## Adoption of Site Cleanup Requirements for UATC and Moonlite Associates 2640 El Camino Real, Santa Clara

Nathan King, PG  
Engineering Geologist  
Toxics Cleanup Division

Cleanup Staff's Response to Comments on Tentative Order for Site Cleanup Requirements  
2460 El Camino Real, Santa Clara, Santa Clara County

# Leaking Sewer Model

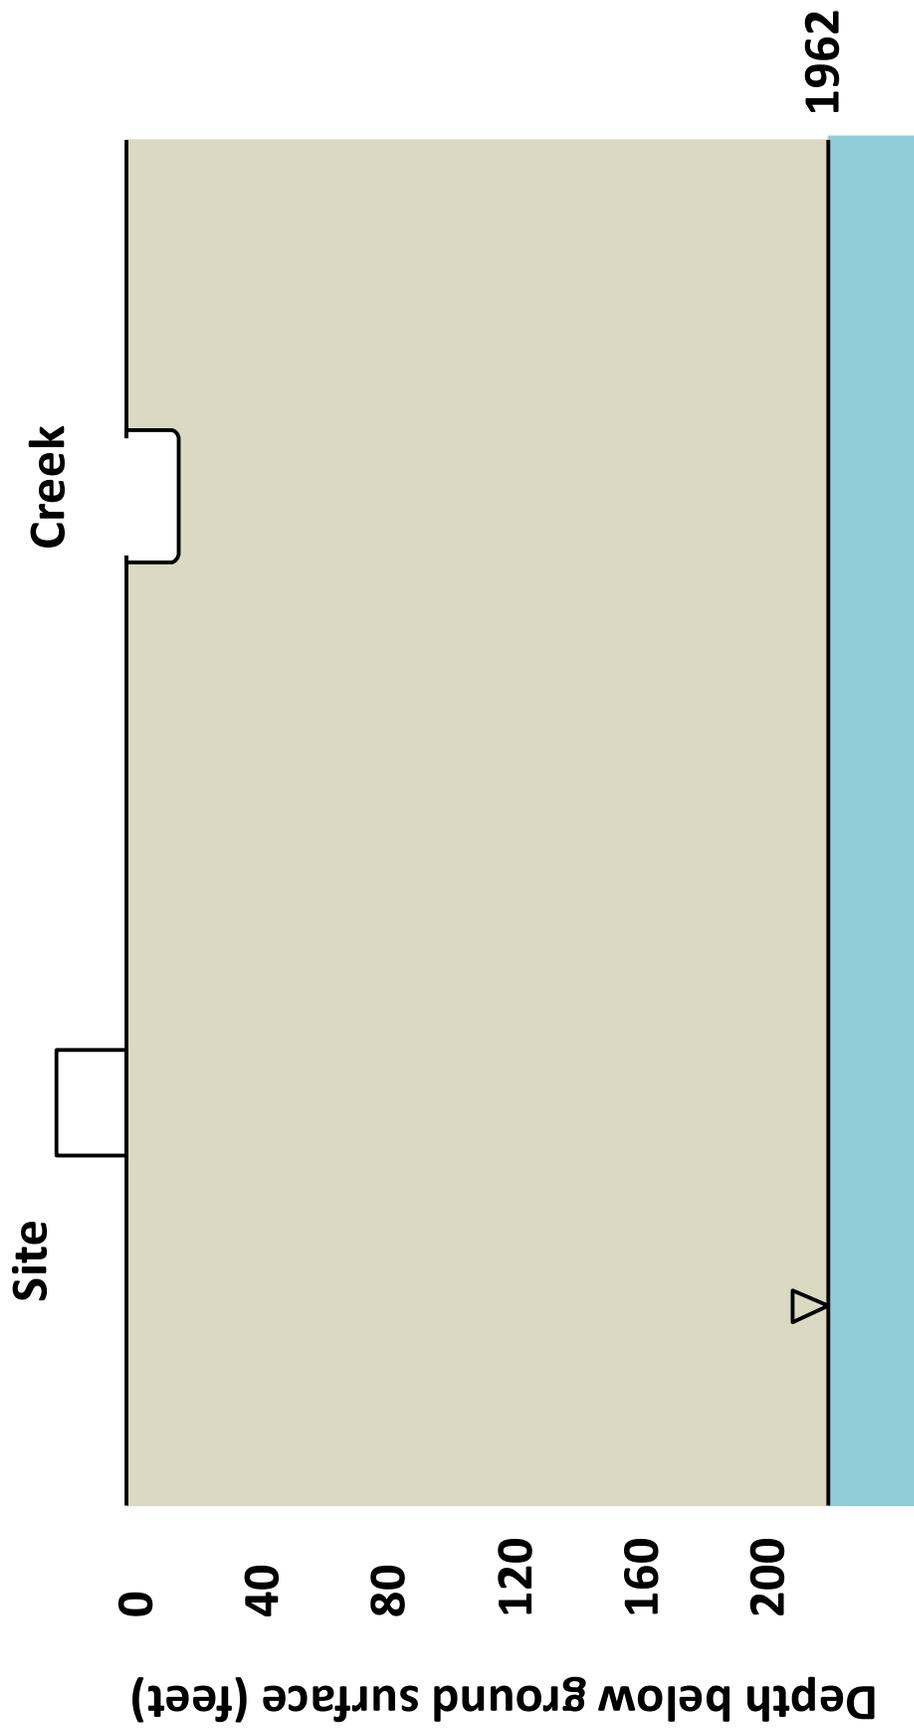
- **UATC: Modeling of PCE leakage from sewer suggest a recent discharge**
- **Response: Model doesn't incorporate primary release mechanism**

**Site Relative to Saratoga Creek Under Losing Conditions**  
 Former Moonlite Cleaners  
 2640 El Camino Real  
 Santa Clara, CA

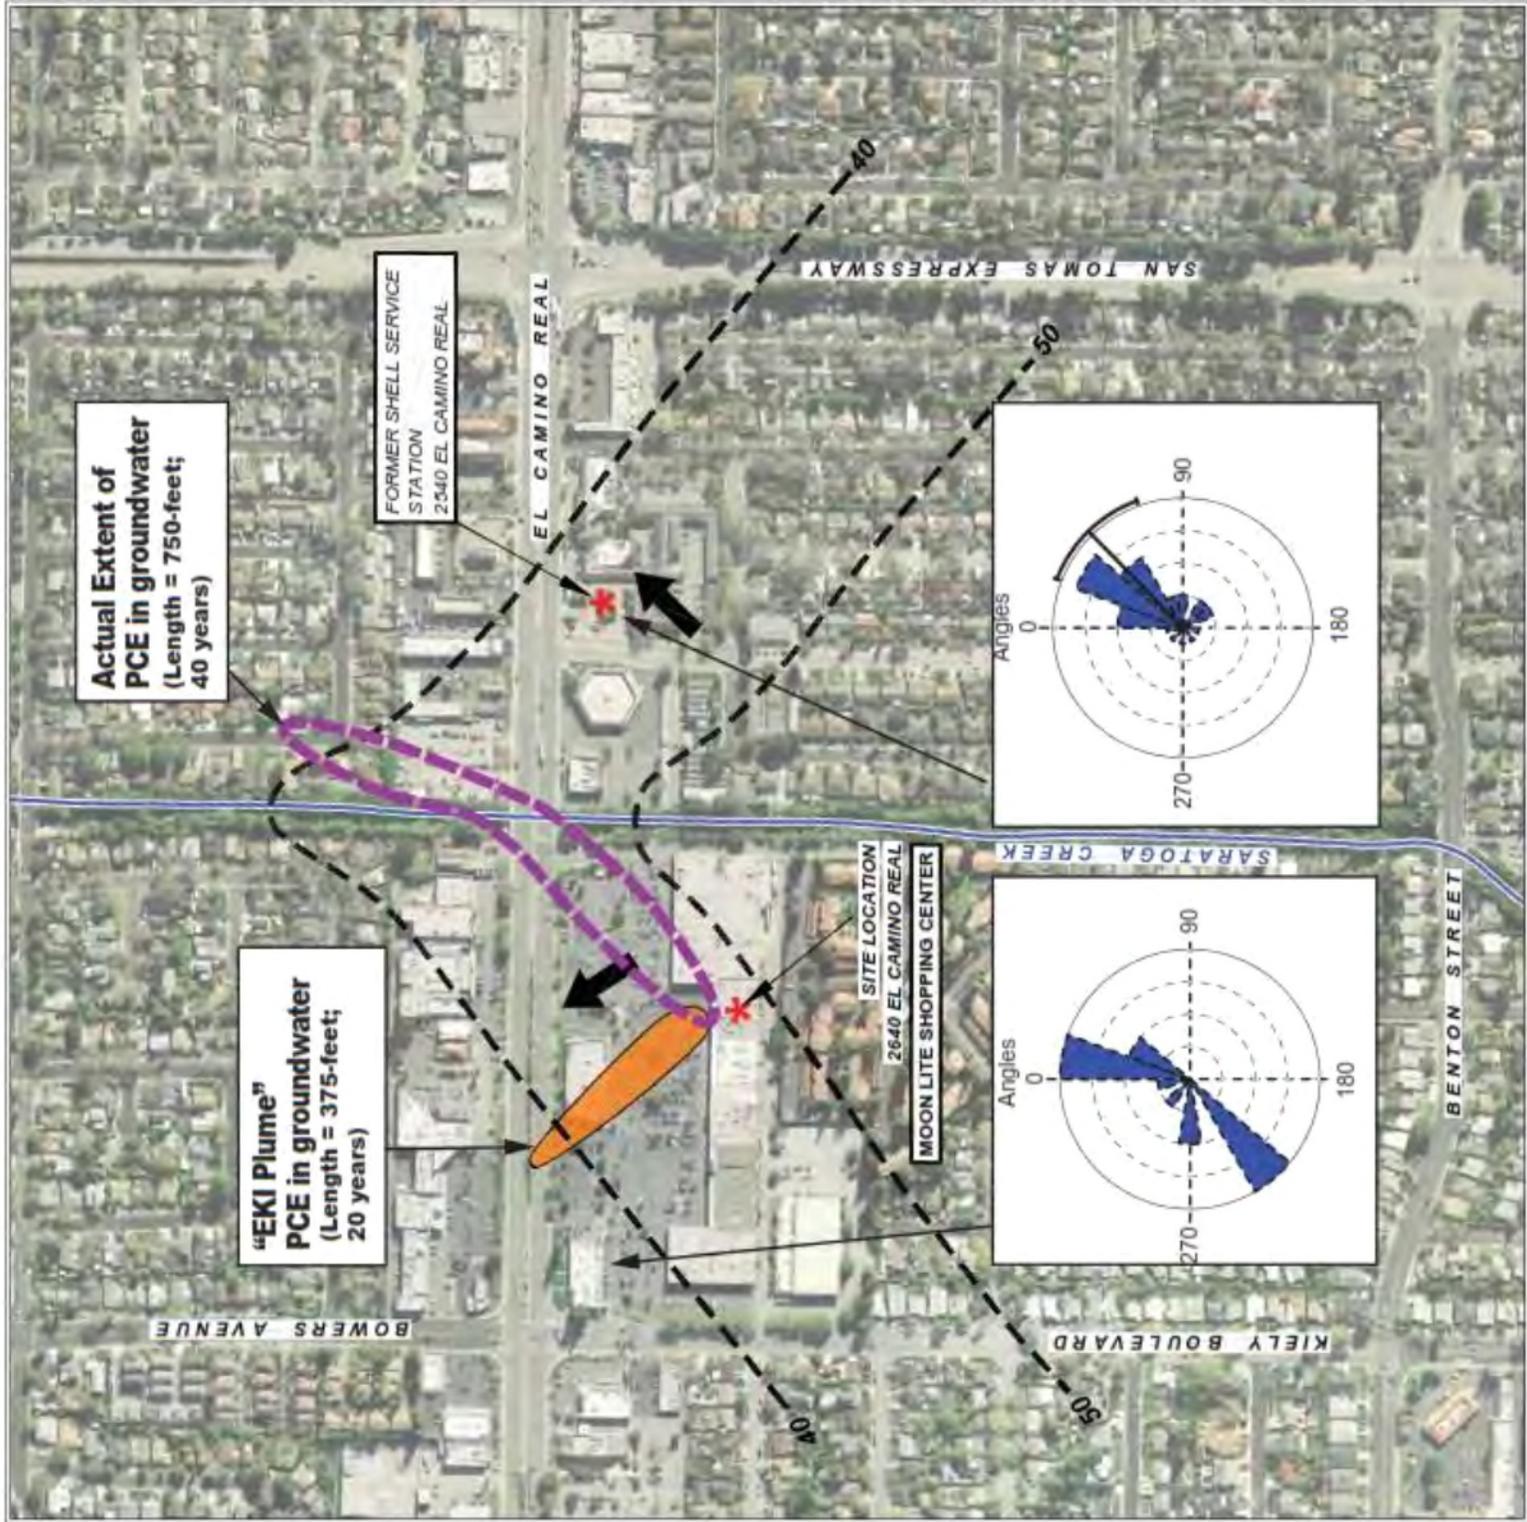
**13c) Comment:** Figure 10 of the EKI report depicts a PCE plume that is shifted approximately 60 degrees counter-clockwise from its present configuration.

**Response:** Cleanup Staff disagrees. This scenario is unlikely. EKI shows a 90 degree shift in plume direction on Figures 10 and 11 of the March 2013 EKI report, and describe it in the text as a 60 degree shift. In comment 13a, EKI is now saying a 41 degree shift took place. EKI should be consistent in its estimation of the magnitude of the purported shift in groundwater direction.
